PROJECT BRIEF

Historic District Board of Review Application for Certificate of Appropriateness at 407 E. Vaughn Dr. to build top floor addition on north side of structure.

Application Date: August 29, 2023

HDBR Meeting Date: September 25, 2023

Sheet Number:
A101

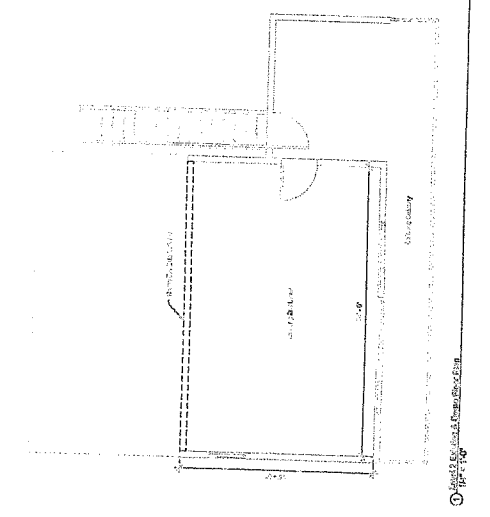
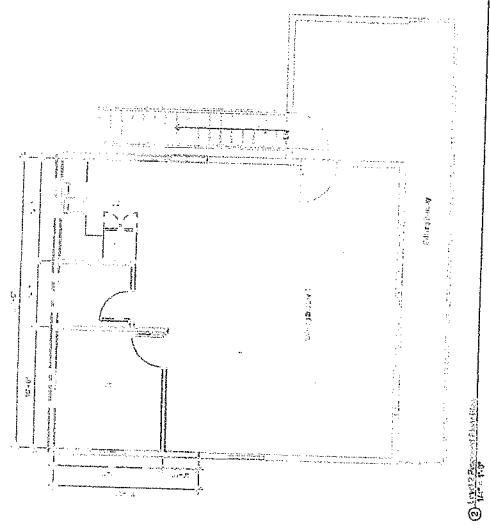
The project *is in* conformance with Guideline 26.1 because the proposed new addition will be placed on the north but is *not in* conformance because the addition will affect a primary façade [this structure is located on a highly visible corner, so all sides are highly visible; however, given its status as a non-contributing structure, the addition will not have any impact upon the designation rating]; *is in* conformance with Guideline 26.2-26.3 because the proposed addition is of the appropriate massing in relation to the existing structure and the new materials will match existing materials; *is not in* conformance with Guideline 26.4 because the new addition will require the demolition of the entire north wall [unknown if the north wall is a historic original wall or contemporary wall]; *is in* conformance with 26.6-26.9 because the new windows will match the existing windows, the foundation will be the

same or compatible to the existing, and prior alterations/additions have been considered and factored in to the design of the proposed new addition; *is in* conformance with the Ordinance because the proposed materials and addition will be visually compatible with the existing structure; and is *not* in conformance with SOI for Rehabilitation because the proposed alterations involve more than minimal exterior visual change.
